Re: Petition No. 1286
West Brookfield Reliability Project
Monthly Construction Progress Report – August 2017

Petition 1286
West Brookfield Reliability Project
Monthly Construction Progress Report
August 2017

WEST BROOKFIELD 14H
YARD EXPANSION - GRADING & EROSION CONTROL
CIVIL PLAN
BROOKFIELD, CT

REV AM ADDITIONS (NEW DRAWING)

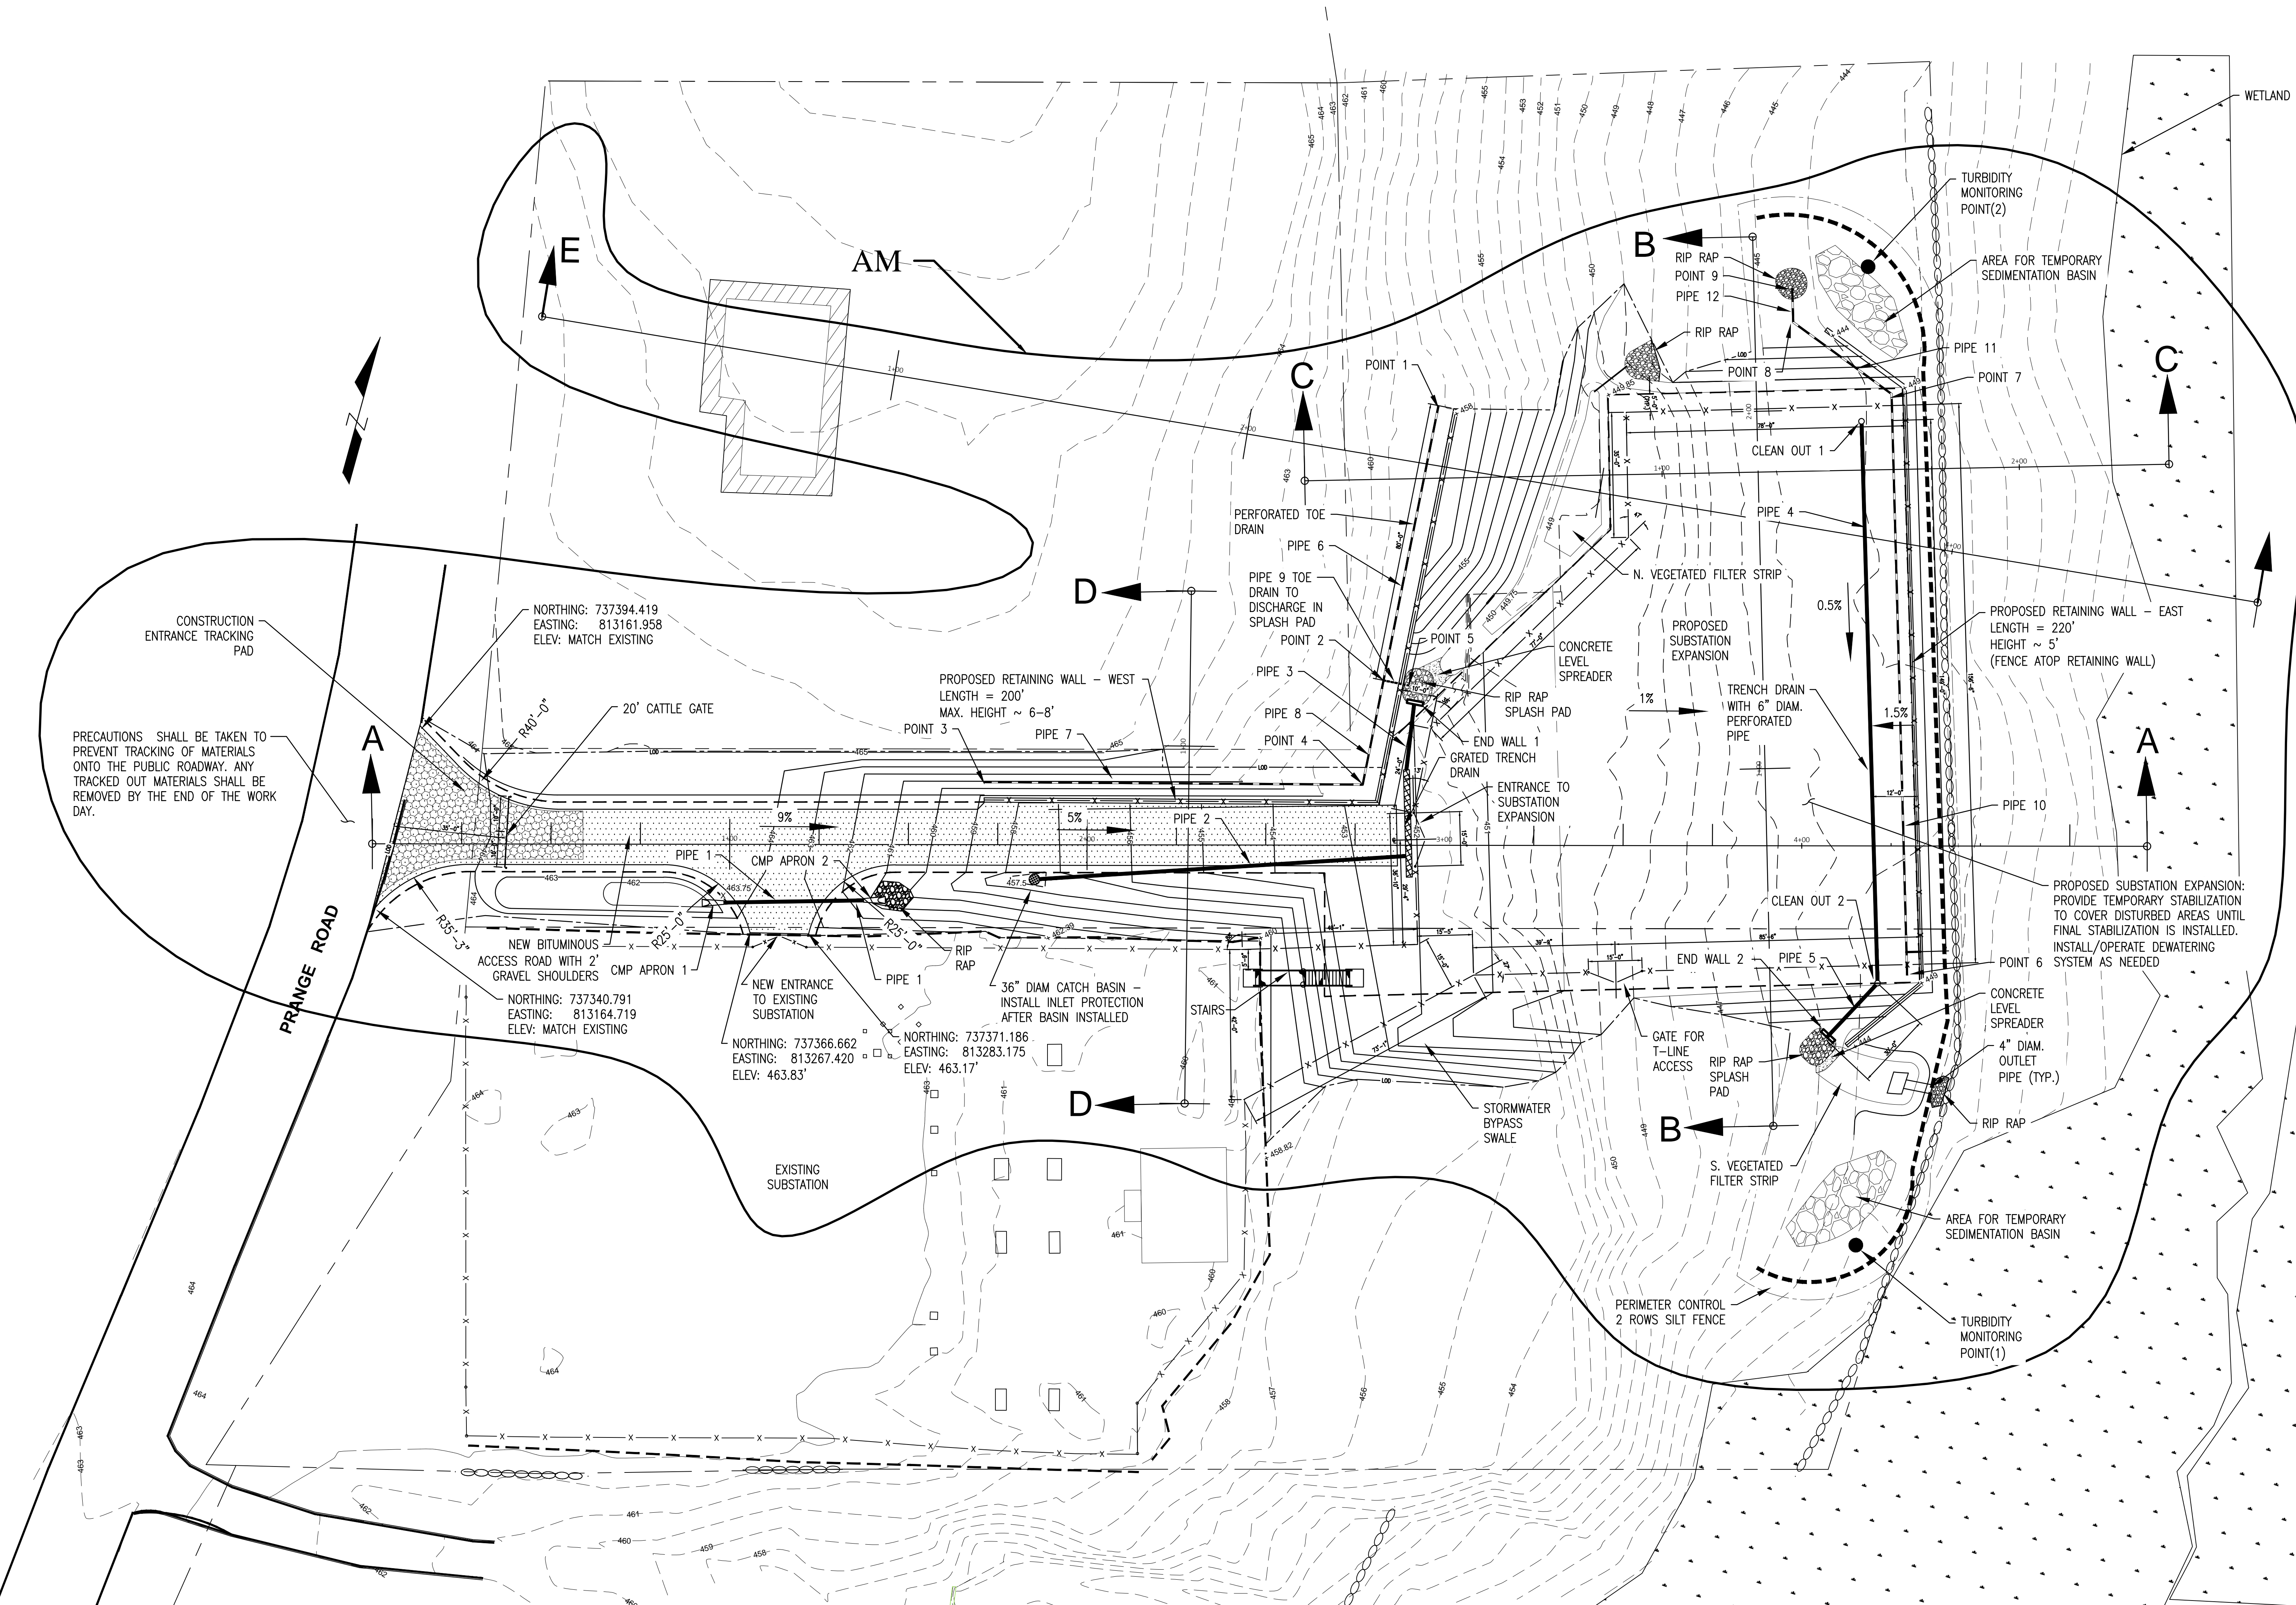
Prior to the beginning of construction, a deficiency with the eastern retaining wall drainage for the expansion yard was identified. To resolve the issue and to ensure no hydrostatic pressure on that retaining wall would compromise its integrity, an additional drainage pipe was installed within the limit of disturbance draining to a new rip rap pad at the north of that retaining wall. See attached "11801-11010-REV AM ADDITIONS" showing the eastern retaining wall area modification.
